ADDENDUM NO. 7

HVAC & CONTROLS REPLACEMENT/ADDITION AT NINE (9) SITES: BARRANCA, BEN LOMOND, CYPRESS, GROVECENTER, MANZANITA, MERWIN, MESA, ROWLAND, AND WORKMAN ELEMENTARY SCHOOLS RFQ/RFP #22-23-105

January 19, 2023

M1.1C

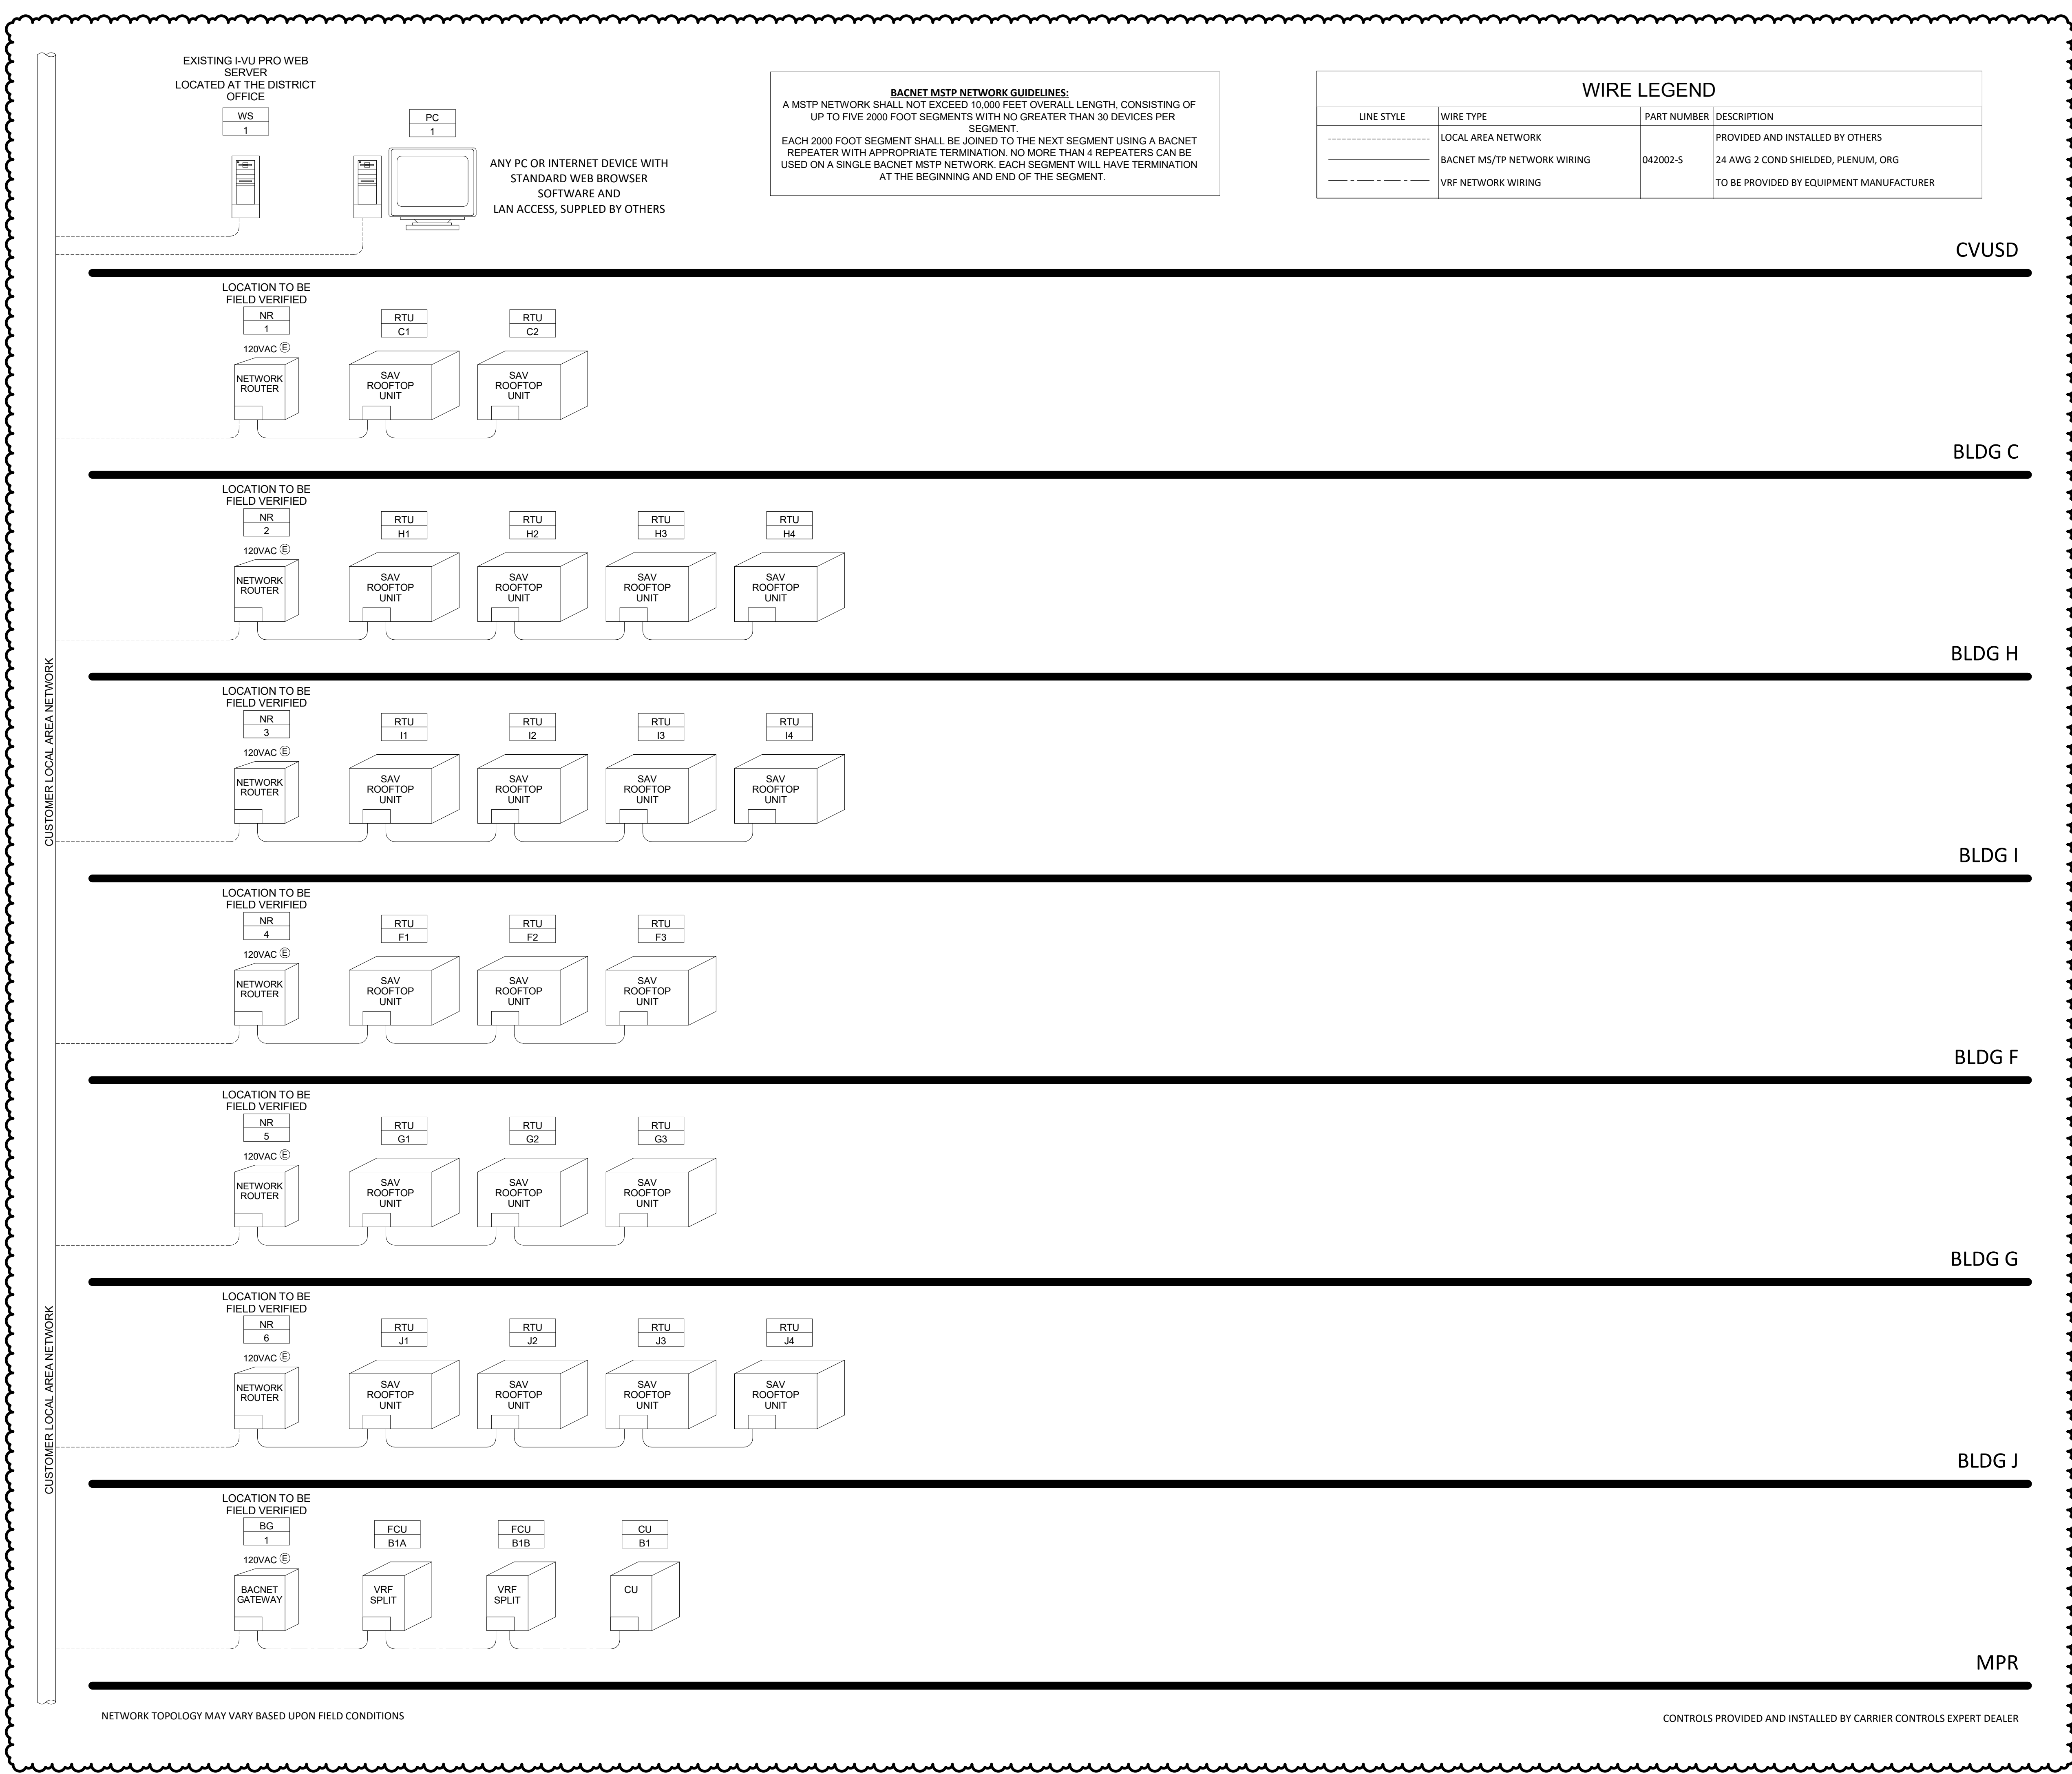
(Page M1.1C):

-Building J: Co2/T-Stat Locations for RTUs J1 Thru J3 are missing. Please provide locations for these sensors.

-Building C: Co2/T-Stat Locations for RTU C3 is missing. Please provide location for this sensor.

DLR Response: See attached updated drawing M1.1C.

M5.1

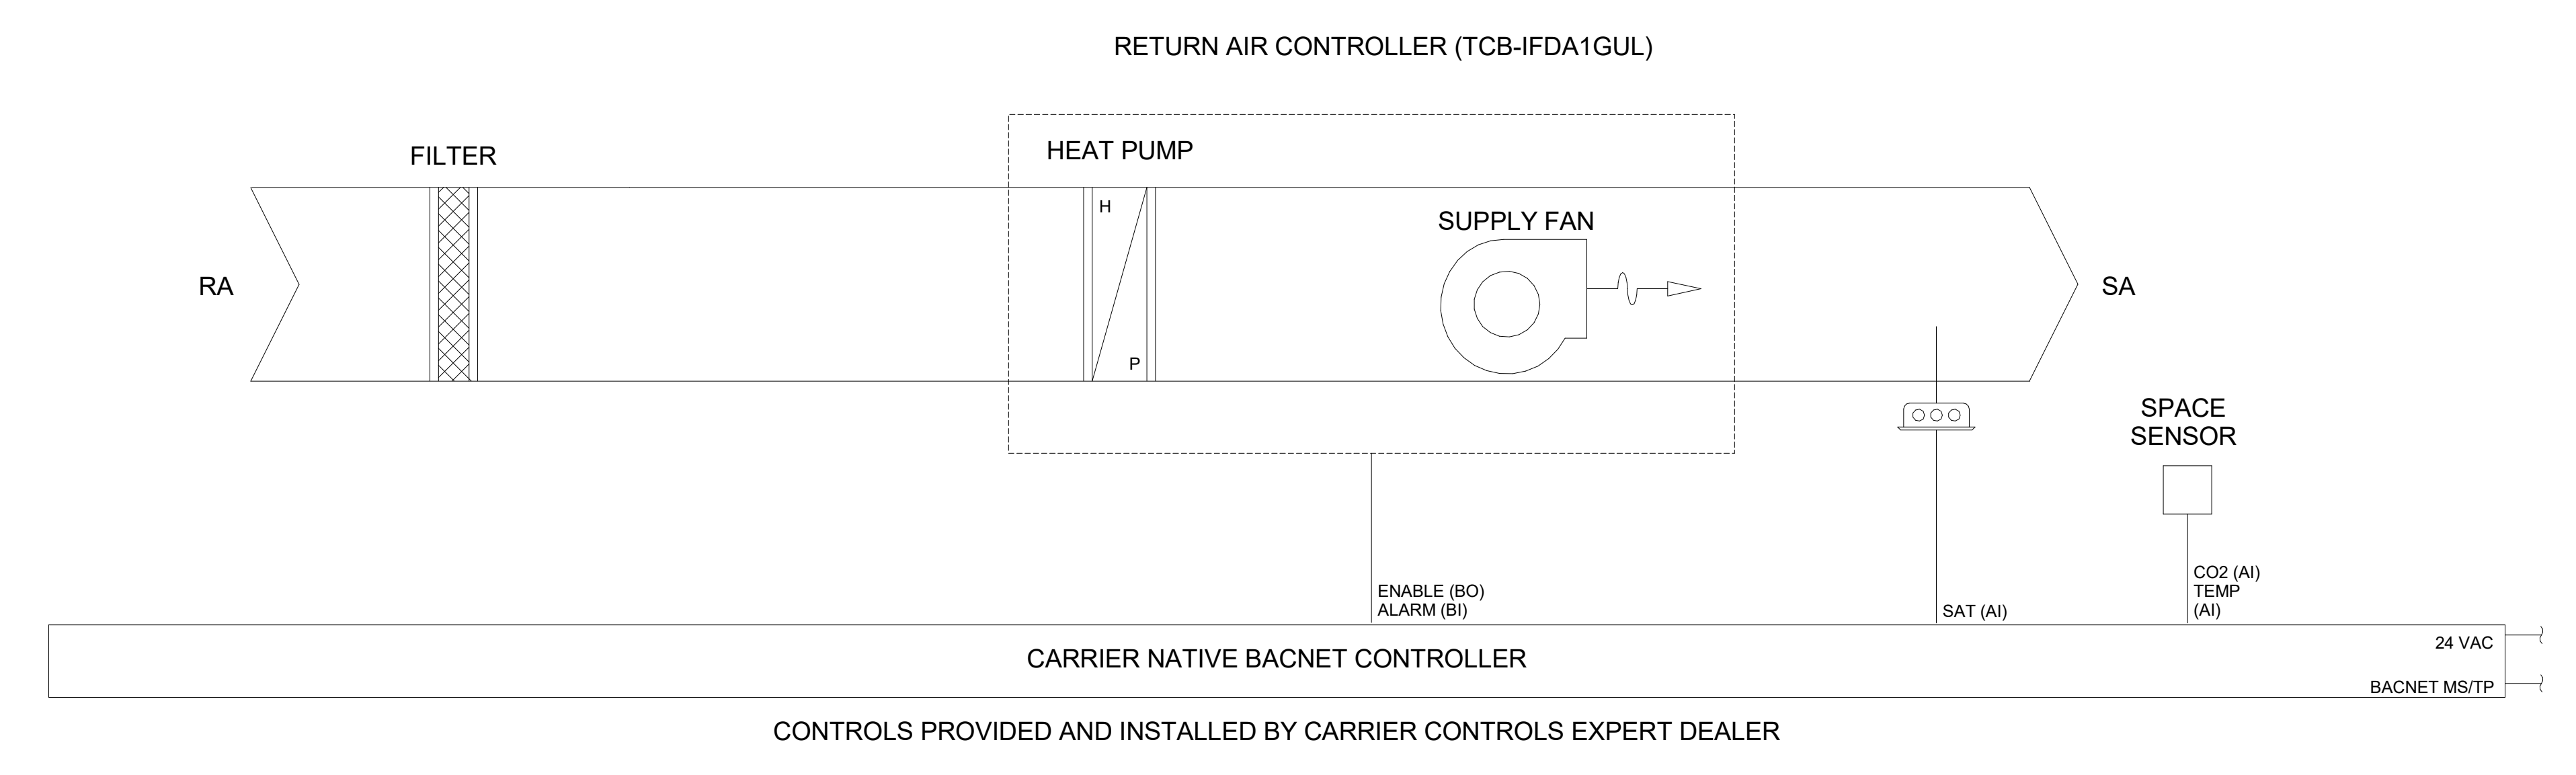
(Page M5.1 And M1.2A/M1.1A)

-ALL Buildings: Per page M1.2A/M1.1A and M5.1 the Floor/Roof Plans do not match the count on the Controls Riser Diagram. Please confirm the number of units that are to be controlled by the carrier i-Vu system as there is discrepancies on the plans. (Need an updated controls riser diagram or floor plans) Please Confirm.

DLR Response: Floor plans are correct. See attached updated M5.1 & M5.2
